Product Name:	HPL - 560	
	Millipacs	
Product Manager:	Pranith Joy	
Subject:	Notification of Change with Immediate Effectivity	
Distribution:	Affected Customers	
Type of Change:	Packaging Change	
Change Description:	Packaging material standardization for Lid and Tray, for ease of manufacturing and improving efficiency. These changes do not affect form, fit and function of the products.	
Reason for Change:	Packaging improvement to meet various customer requirements.	
Affected Parts:	As per list attached	
Effective Date of Change:	May,31 2024	
Last Time Buy Date:		
Earliest Disty Return Date:		
Last Time Shipment Date		
Datasheet Attached?	NA	
Qual/Test Data Attached?	NA	
Samples Availability Date:	23 May ,2024	
Available Alternatives?		
Questions?	Contact your local ACS Representative, or Product Manager	
	Pranith Joy / Product Manager	
	Pranith.Joy@amphenol-fci.com

LID; P/N: BLISTERDEKHM2R

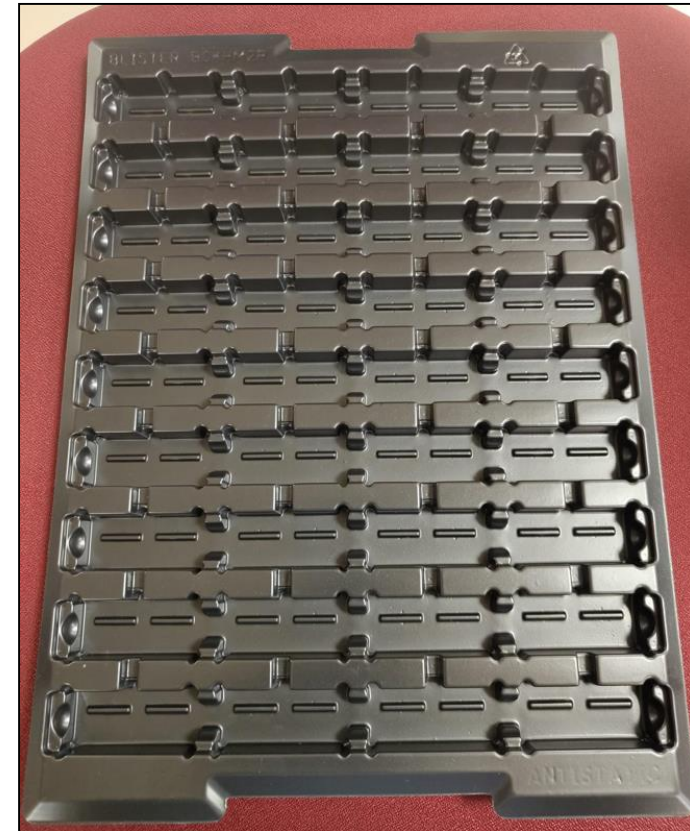
Due to the improvement of the lid material, There is a noticeable change in the appearance of lid.
